Subject: Notification of Planned Change to the Permitted Facility Regarding the  
Excavation and Construction of Shaft and Associated Drifts, Hazardous Waste  
Facility Permit, Number: NM4890139088-TSDF

**New Shaft and Connecting Drifts  
(Conceptual Drawings Only)**

Figure 1: Proposed Surface Location of New Shaft

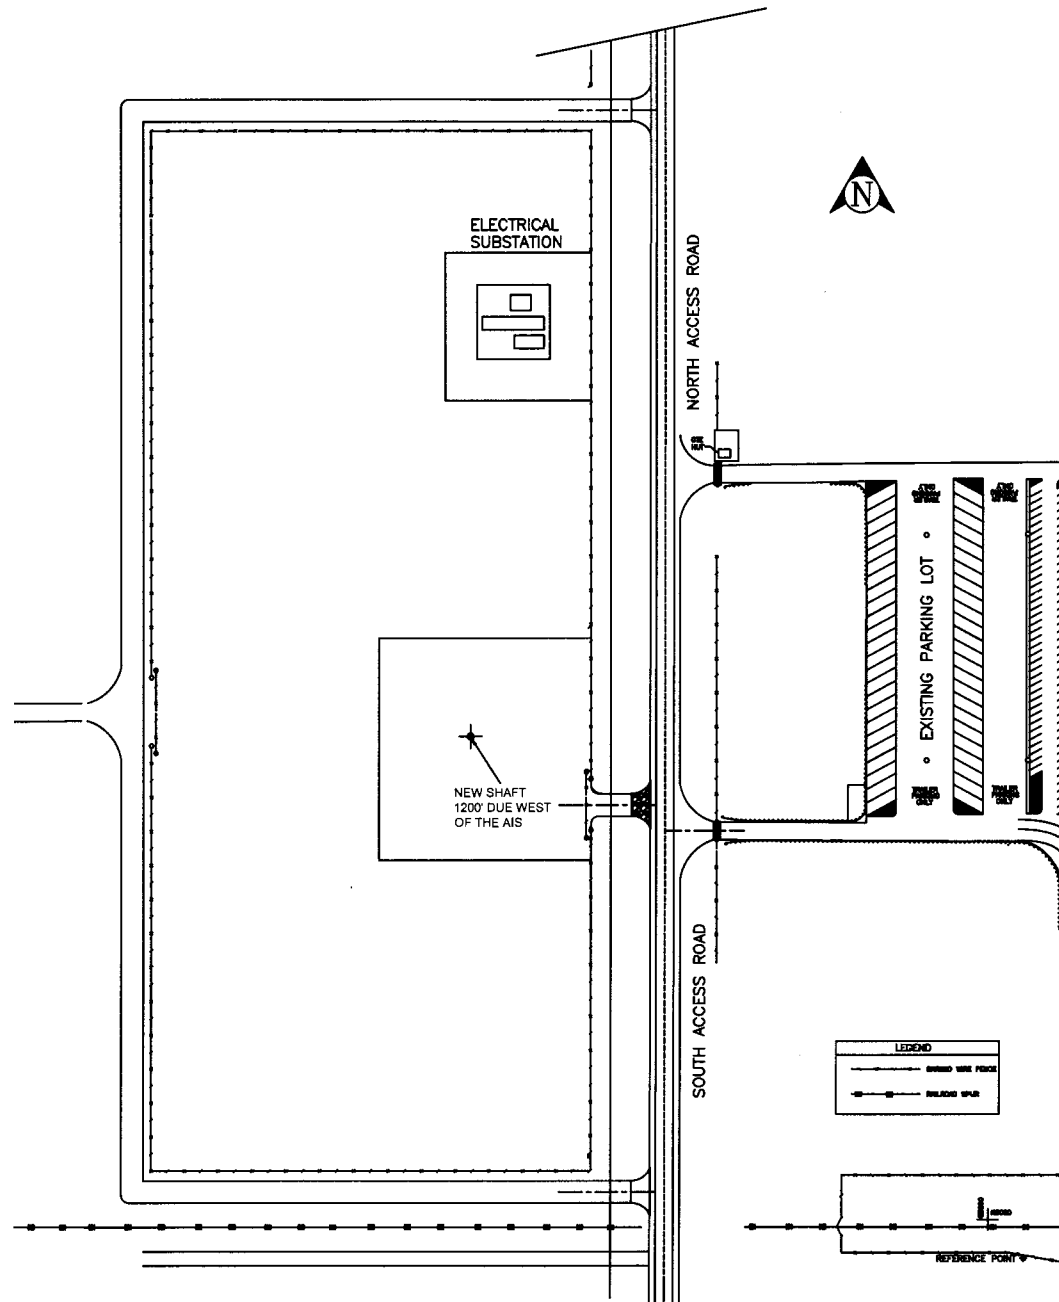
Shaft Number 5 will be located approximately 1,200 feet west of the existing AIS. Surface-mounted fans are planned to be used to downcast air into the underground via S#5. The air from the S#5 will primarily be used to ventilate the Construction and Disposal Circuits through the new connecting drifts. Exhaust air from the North Disposal and Waste Shaft Station Circuits are planned to be exhausted through the existing Exhaust Shaft. Exhaust air from the Construction Circuit is planned to be routed through the existing AIS. The enclosed document provides the conceptual drawings of S#5 and associated facilities.

Figure 2: Proposed Underground Location of New Shaft and Connecting Drifts

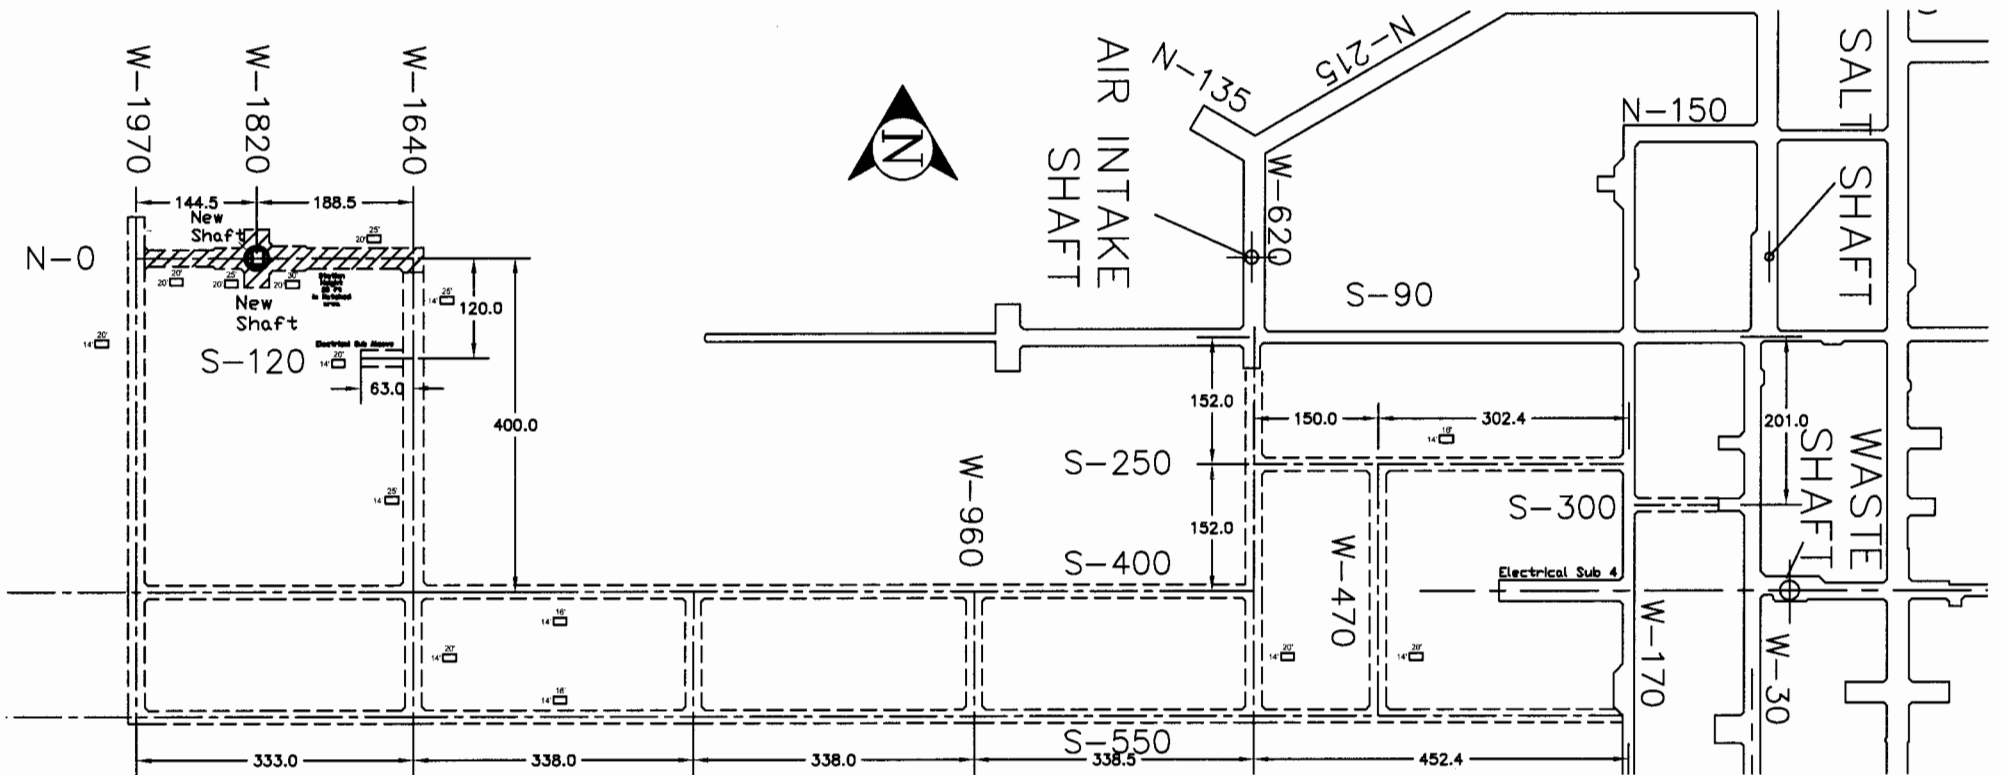
PROPOSED DRIFTS TO CONNECT THE NEW SHAFT TO THE REPOSITORY
